City of Mississauga Department Comments

Date Finalized: 2023-07-05 File(s): A17.23

The applicant requests the Committee to approve a minor variance to allow an existing driveway with a width of 8.50m (approx. 27.89ft) whereas By-law 0225-2007, as amended, permits a maximum driveway width of 6.00m (approx. 19.69ft) in this instance.

Property Address: 1546 Highbrook Ave

Appendix 1 – Transportation and Works Comments

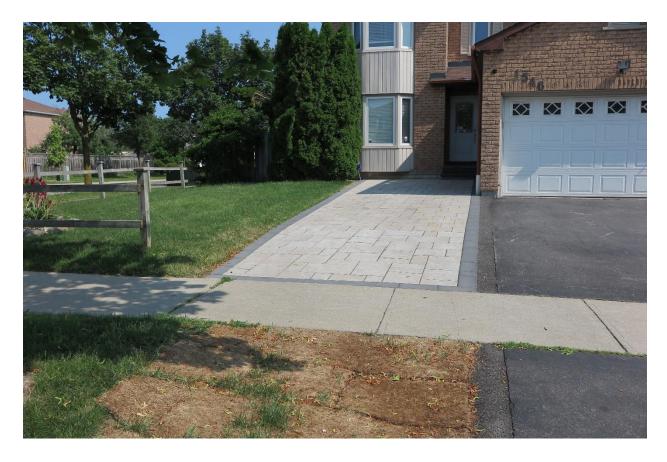
This department notes that with regard to the widened driveway within the municipal boulevard (the area between the municipal curb and property line) we would request that this area be reinstated with topsoil and sod should the application be modified to reflect a smaller driveway width within the subject property or if the application is not supported by the Committee.
